ADDENDUM NO. 002

RE: Bristol Community Health Center, Phase I Renovations
For Southwest Virginia Community Health Systems
T&L Project No. 16493

DATE: April 4, 2023

Sheet No.
A102

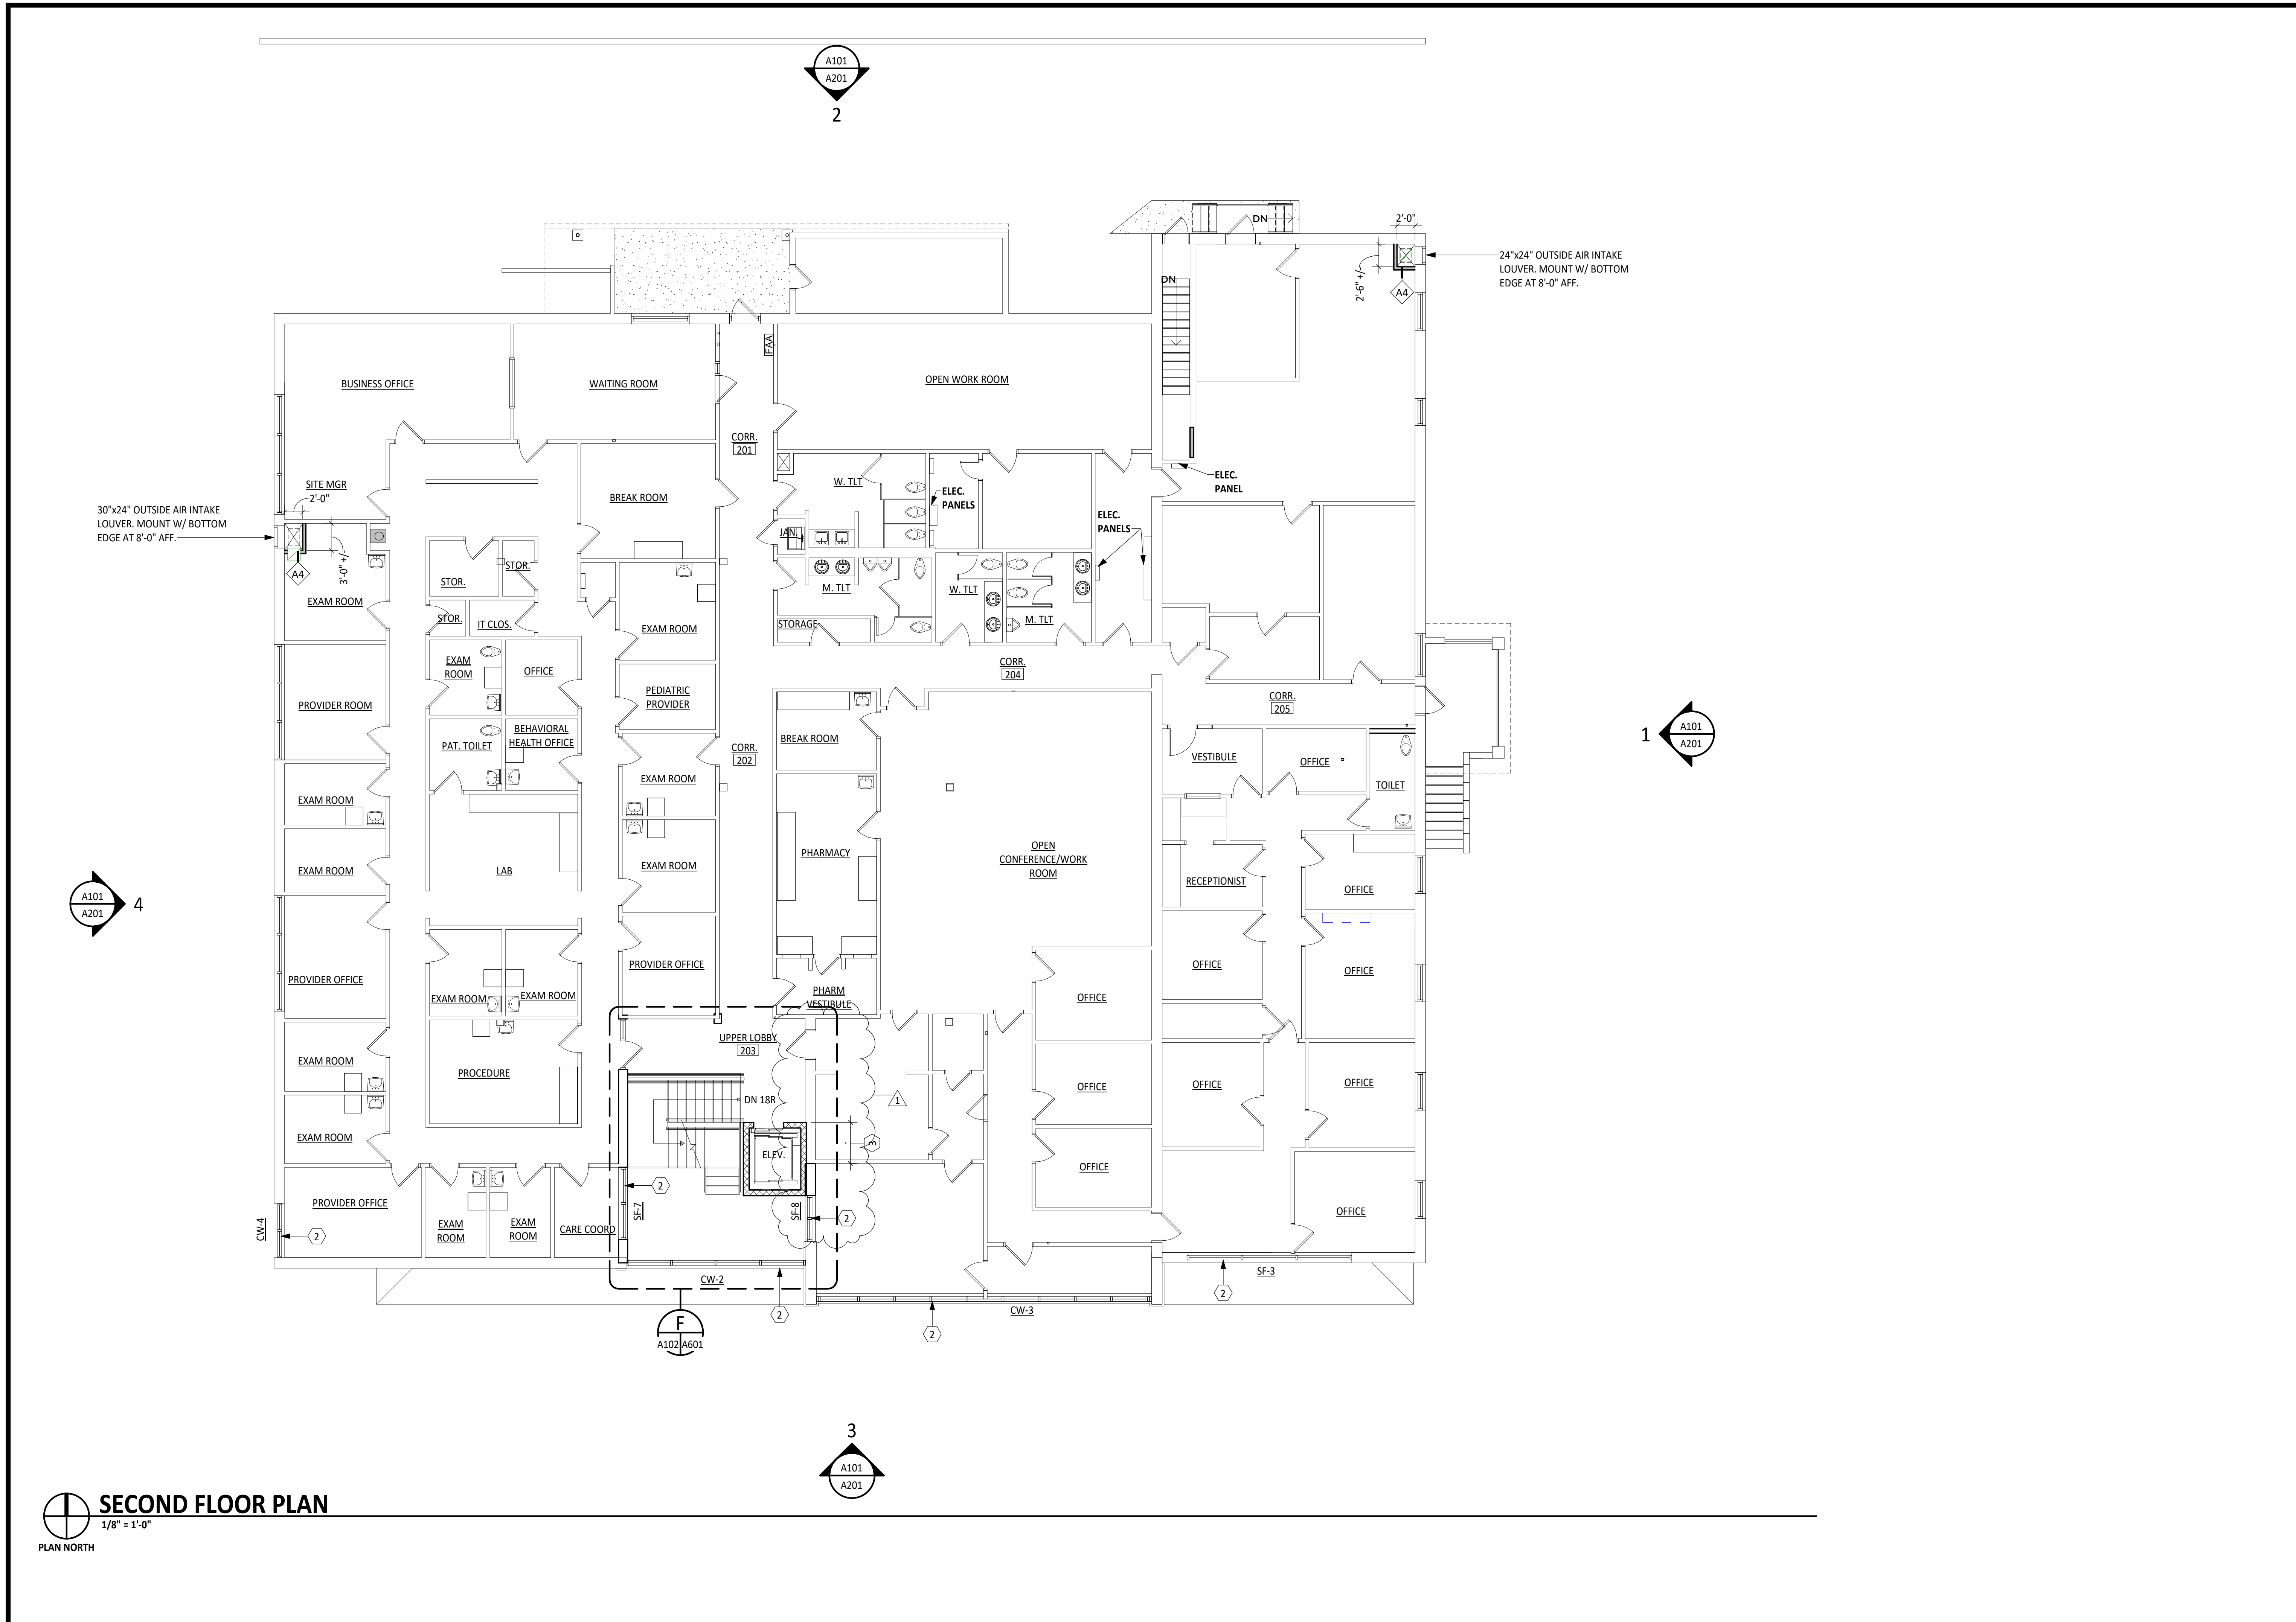
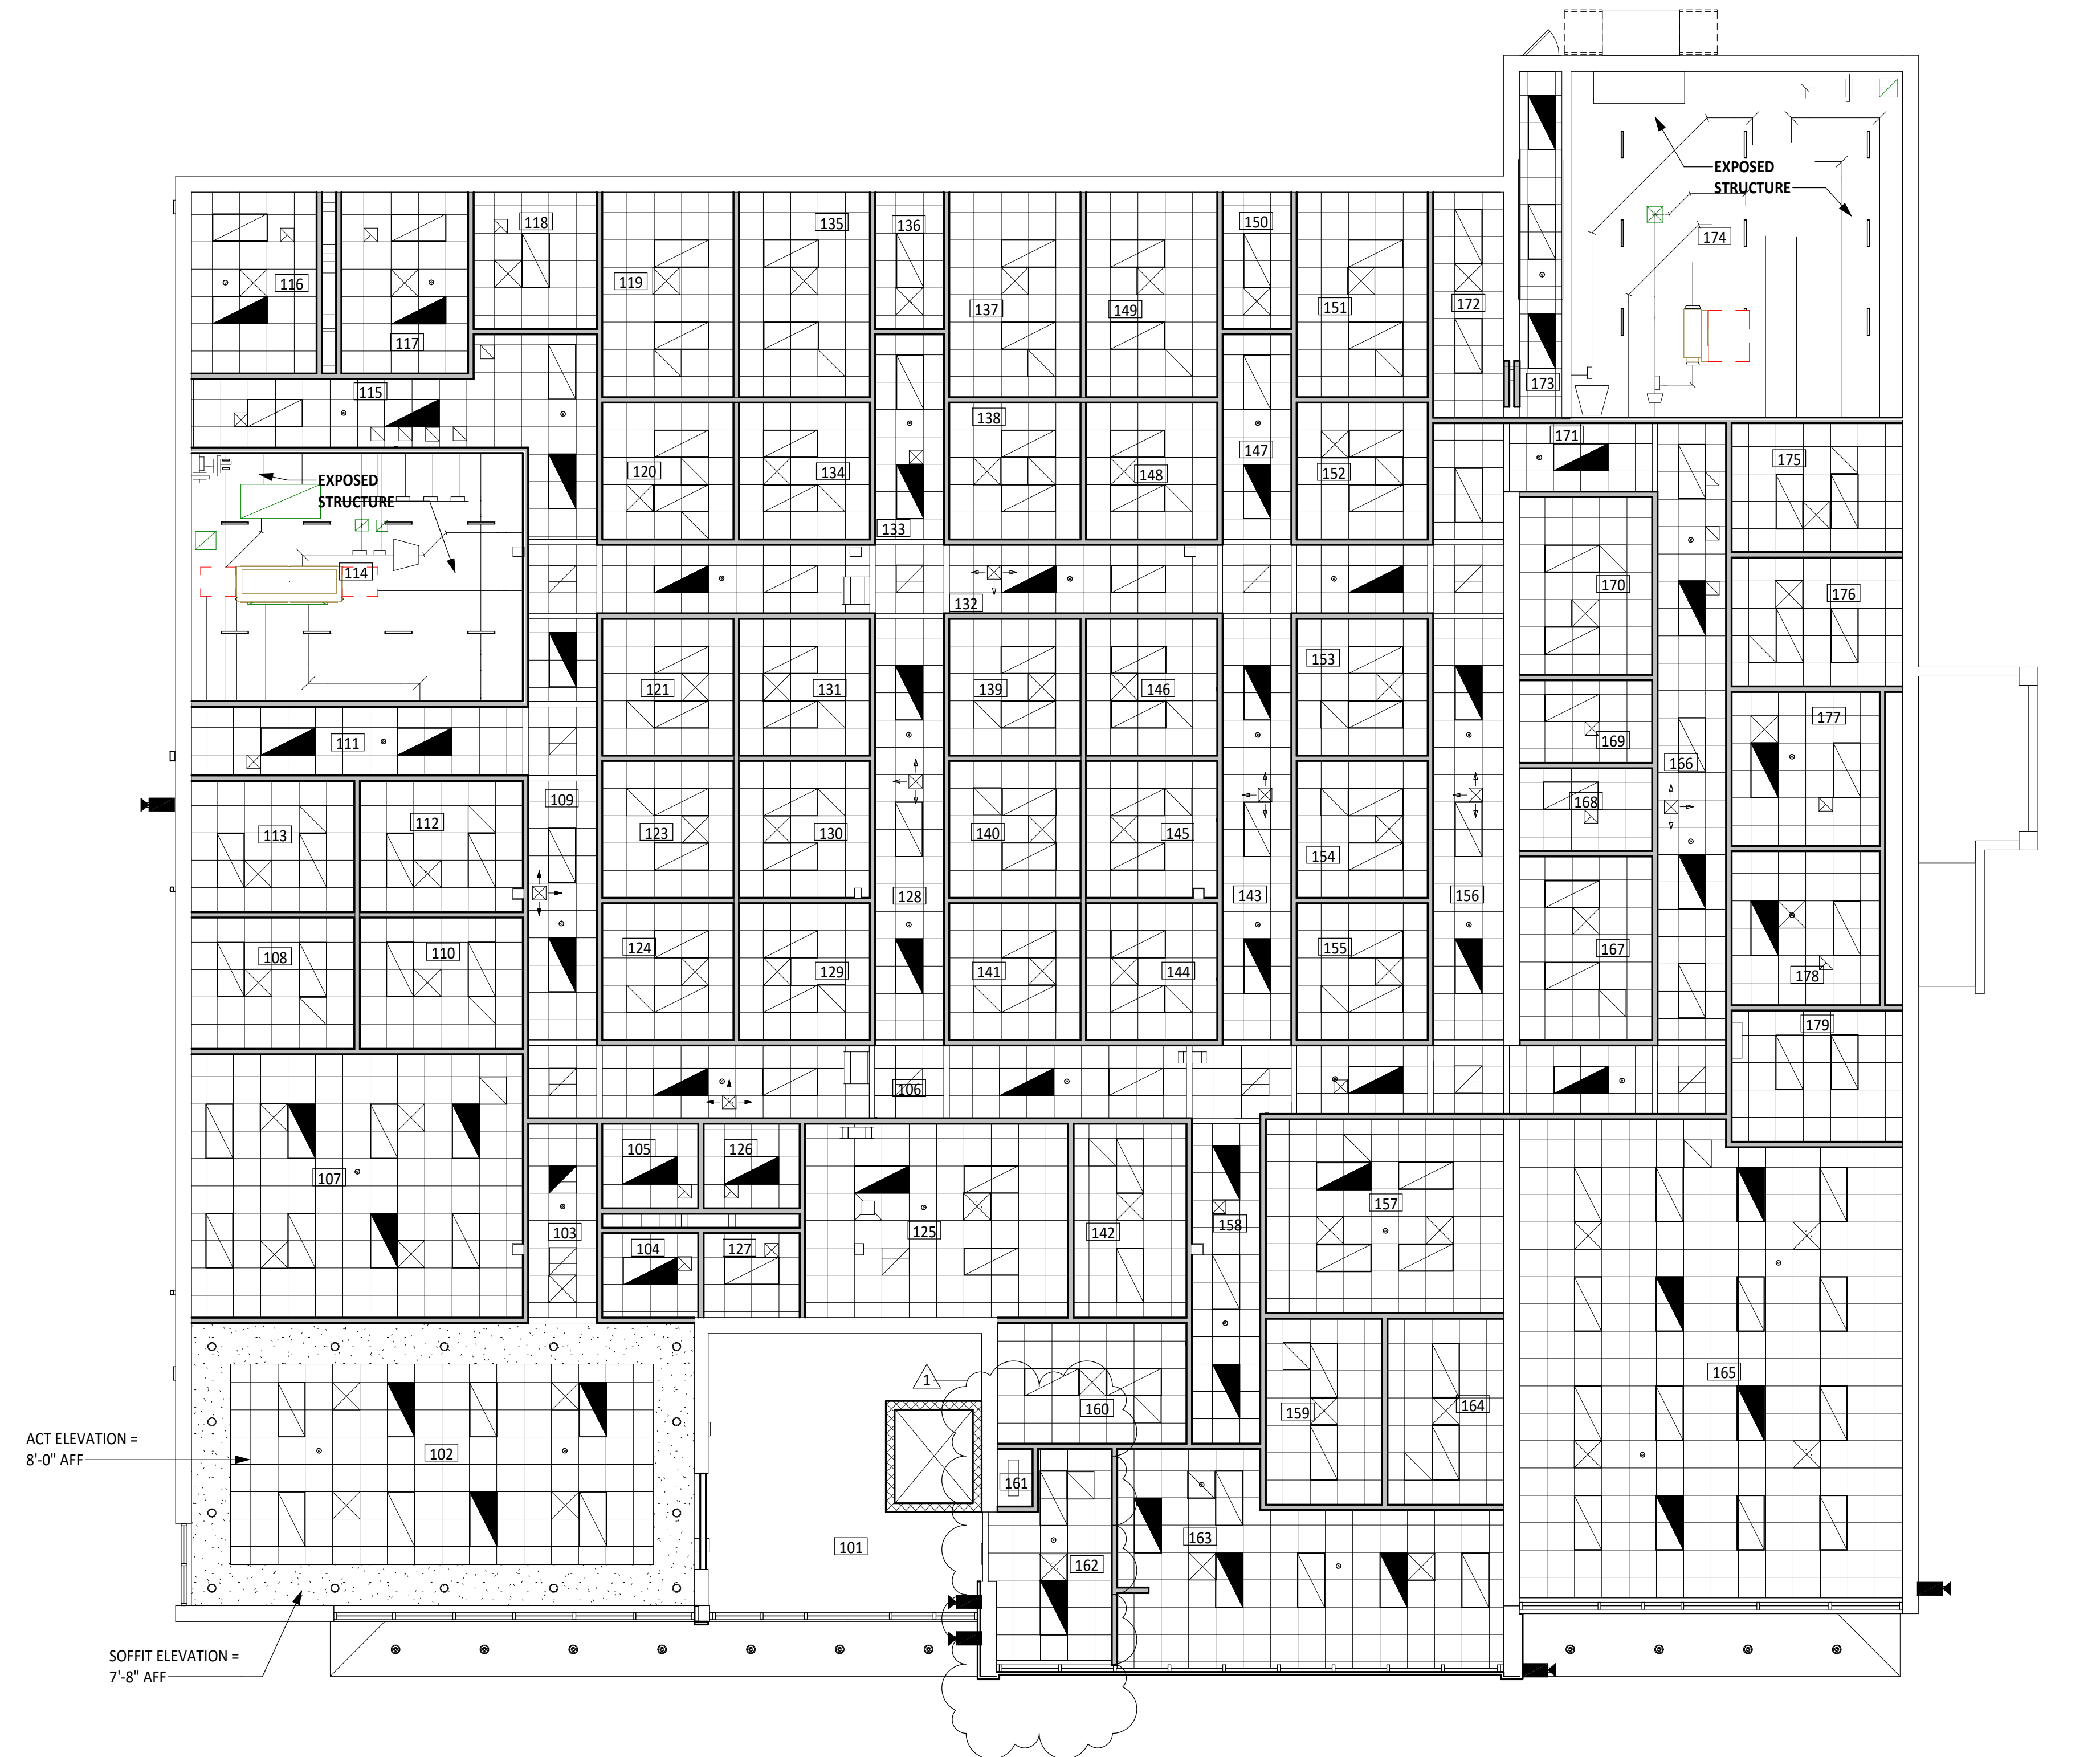
1. Refer to Drawing AD101 for clarification of selective demolition extent at elevator location.
2. Refer to Drawing A101 for revised number and spacing of Aluminum Storefront Elevation (SF-4), and relocation of elevator machine room
3. Refer to Drawing A102 for clarification of existing versus new work at new elevator location.

Sheet No.
A103

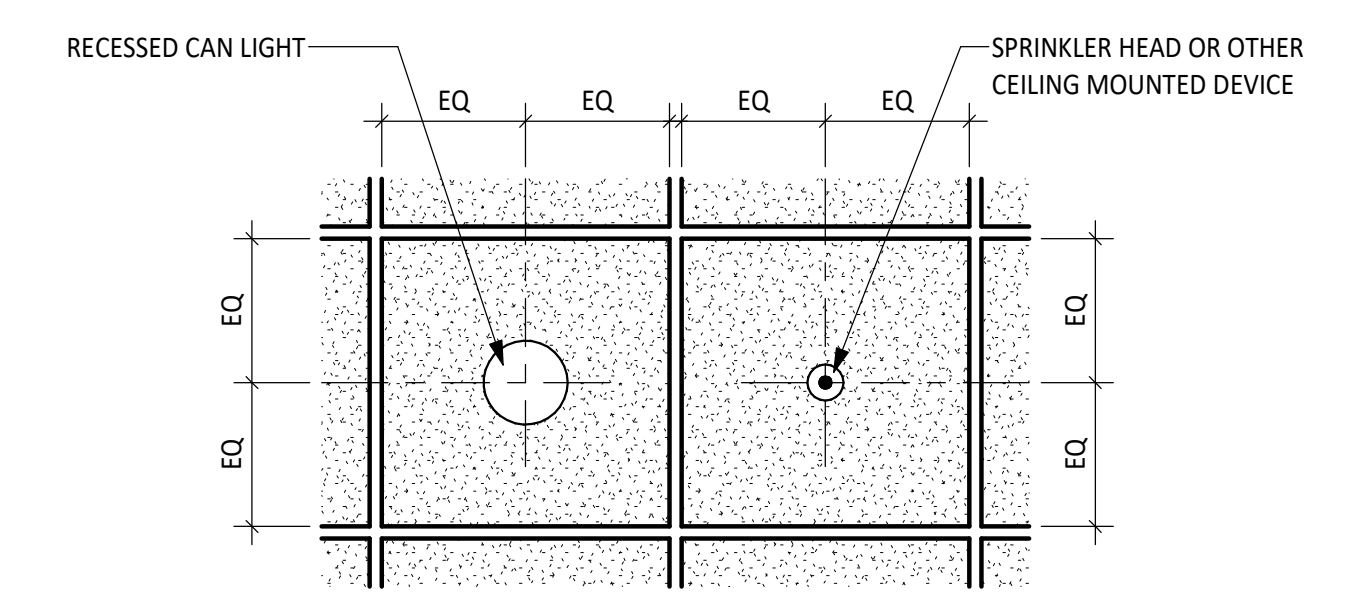
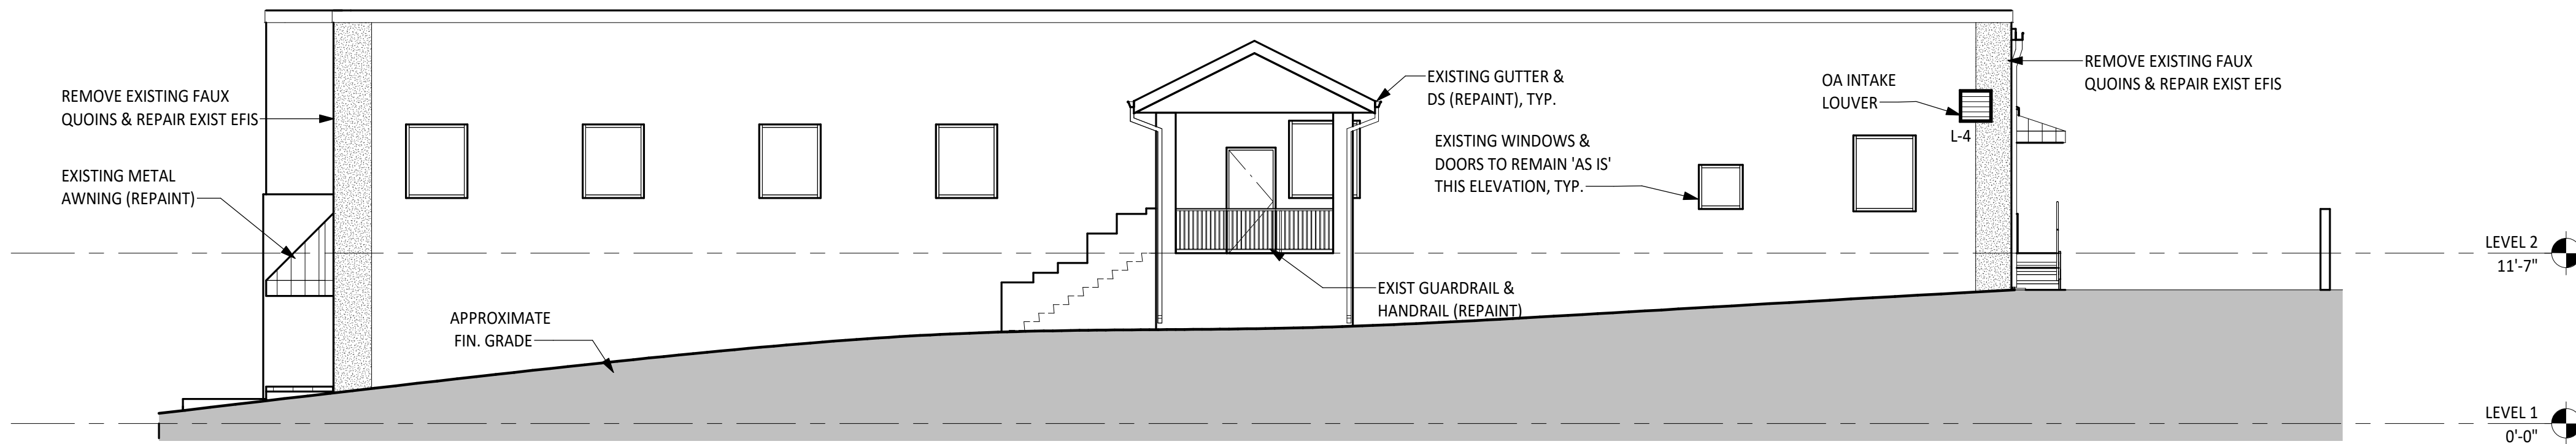
4. Refer to Drawing A103 for revisions to reflected ceiling at relocated elevator Machine Room 161 and Vestibule 162.
5. Refer to Drawing A601 for revisions and clarifications at elevator and machine room.
6. Refer to Drawing A201 for revised number and spacing of Aluminum Storefront Elevation (SF-4) and locations of wall cap WC-1, and louvers L-1 & L-2.
7. Refer to Drawing A701. Add new note no. 9 to General Partition Notes that reads, "Provide new 2-1/2" metal Z-furring at Partition Type A0.
8. Refer to Drawing A713 for revised Aluminum Storefront Elevation (SF-4).
9. Refer to Drawing S001 for "Typical Detail – Slab Replacement @ Utility Trench" and "Typical Detail – New Window Opening Existing Exterior Wall".
10. Refer to Drawing S100 for revised elevator shaft plan revisions.
